SKP/15230-06
26th July 2017

JOB TITLE Skimmingdish Lane		CLIENT Albion Land	
DRAWING TITLE Max Legal Artic Tracking			
SCALE 1/500@A3	DRAWN BY BP	DATE July17	DRAWING No 15230-18
		REVISION

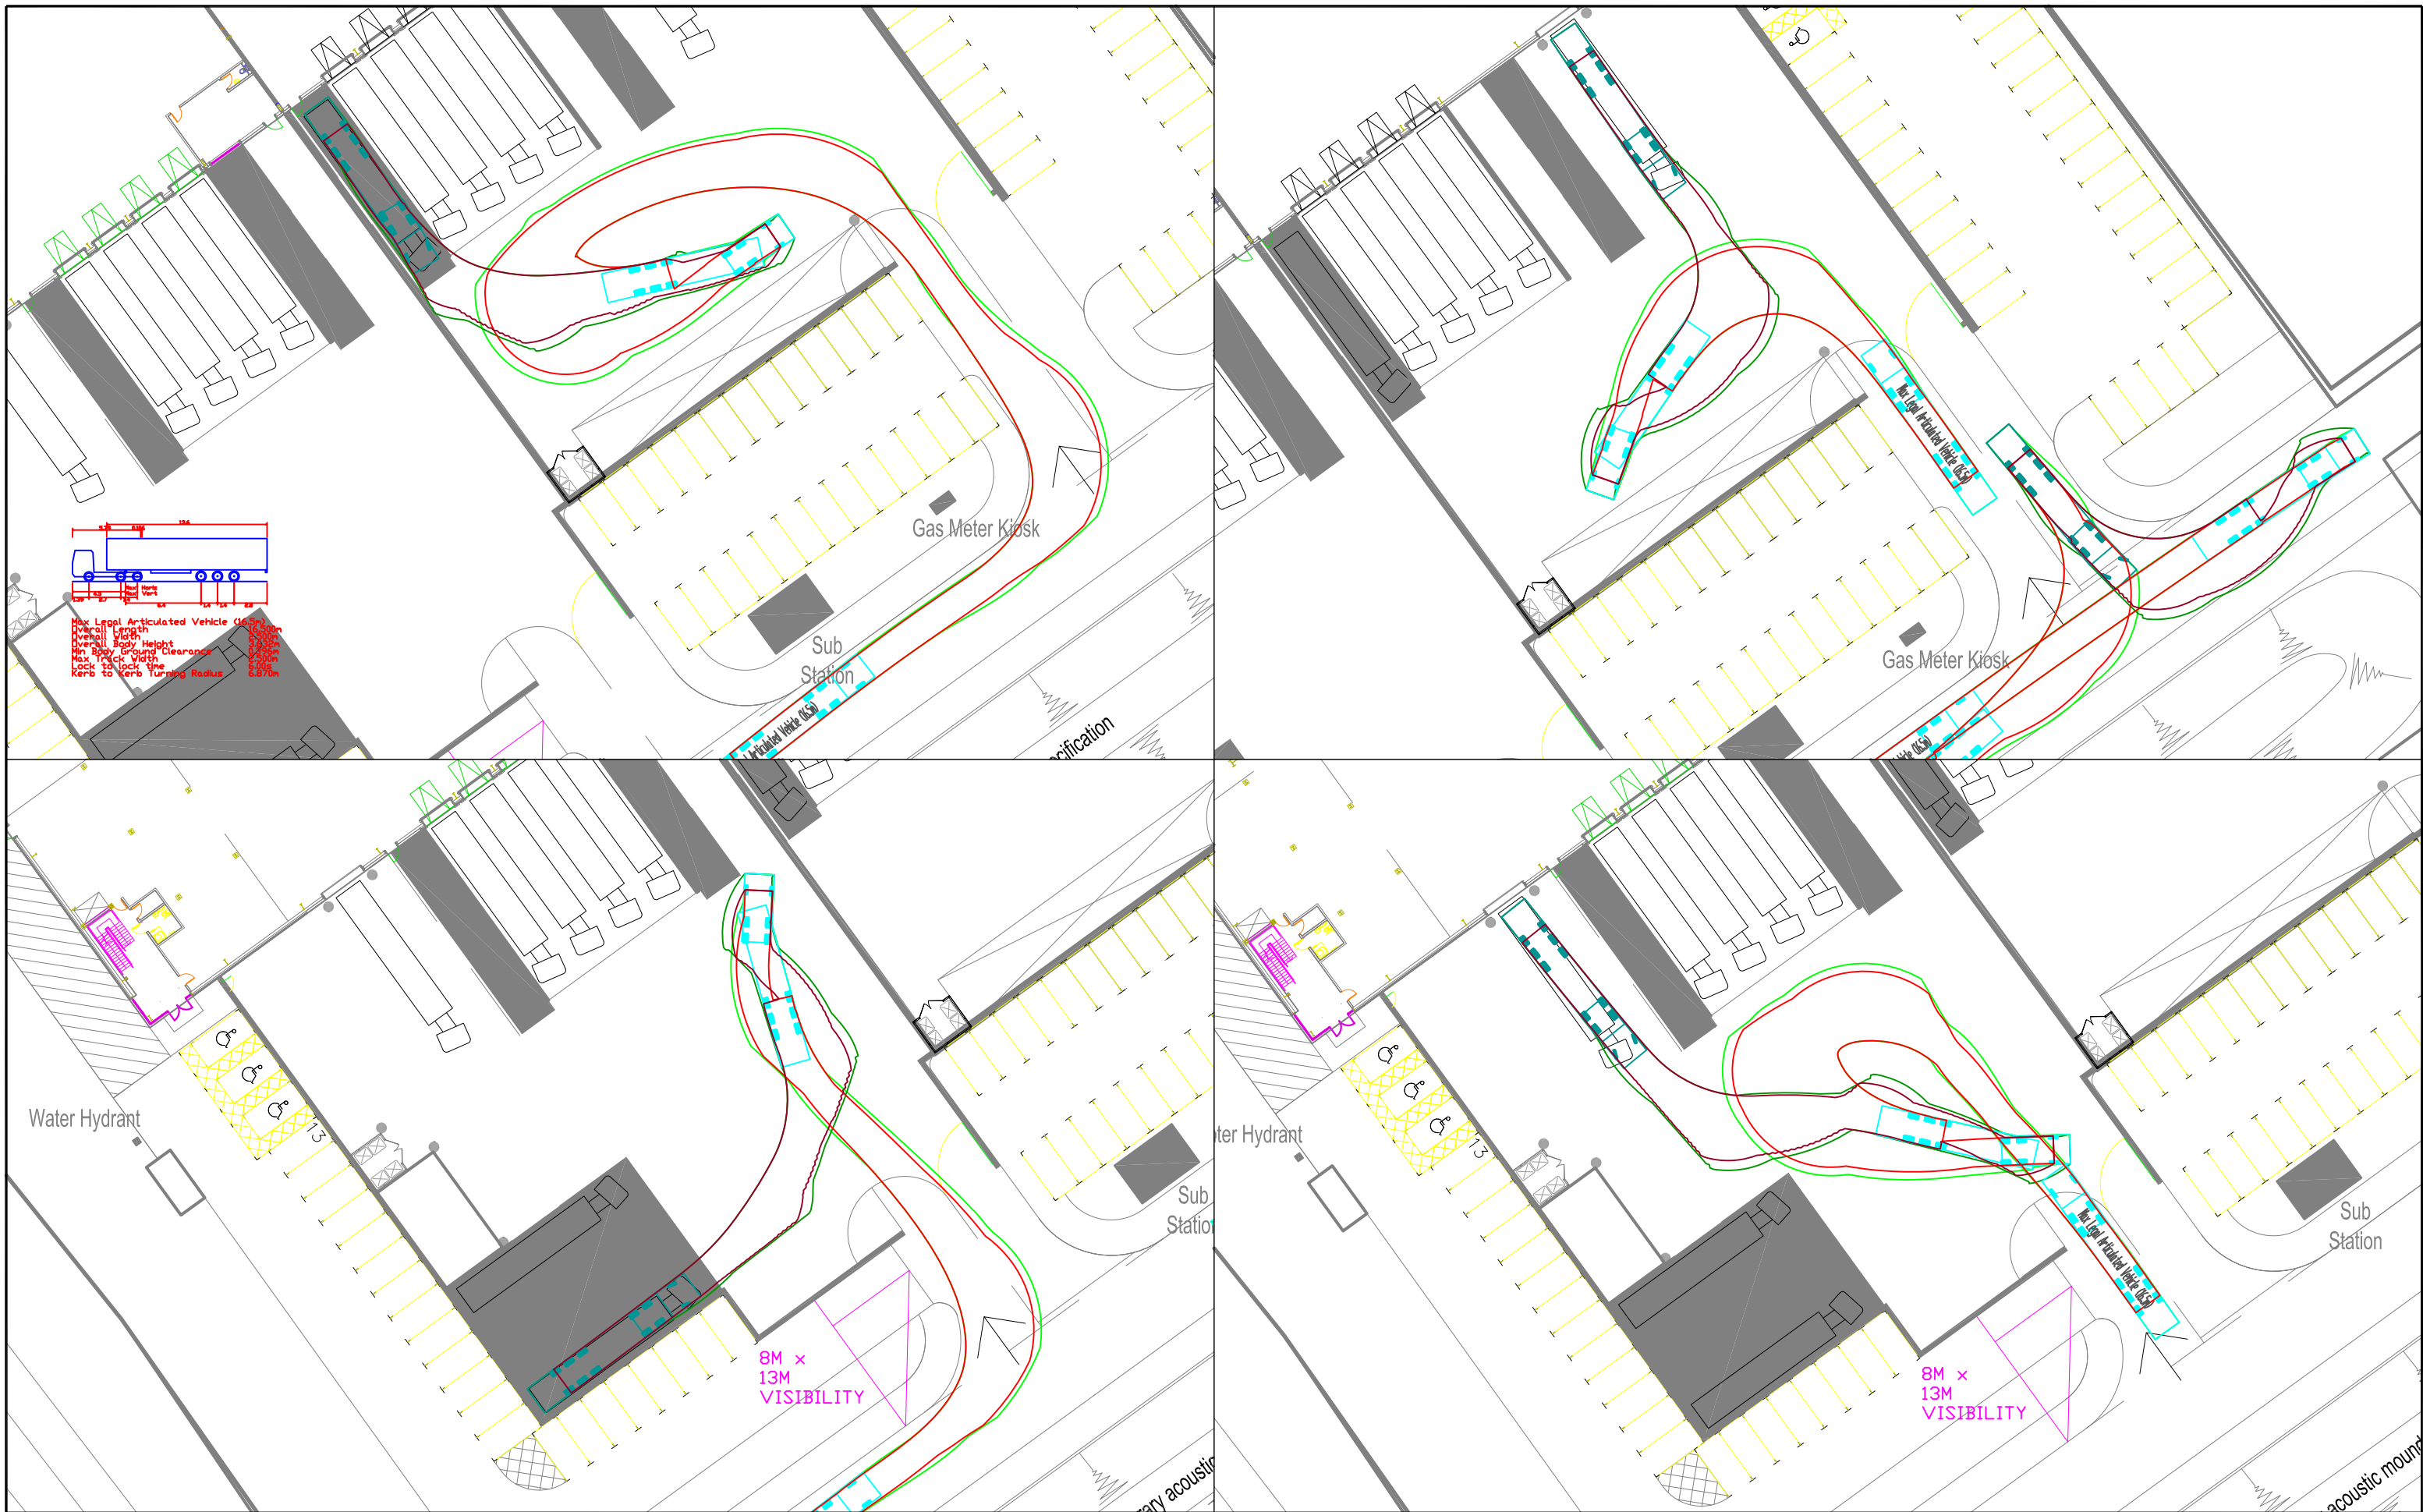
-
- 6.0 Vehicle tracking is provided as shown on **DTA Drawing 15230-18** to illustrate that HGVs can manoeuvre in the service yards, to enter and exit in forward gear.

- 7.0 Temporary turning opportunity is illustrated for HGVs on **DTA Drawing 15230-18** which accommodates any vehicle unable to travel further east on the spine road, by turning in front of the gates proposed as part of Unit 3A.
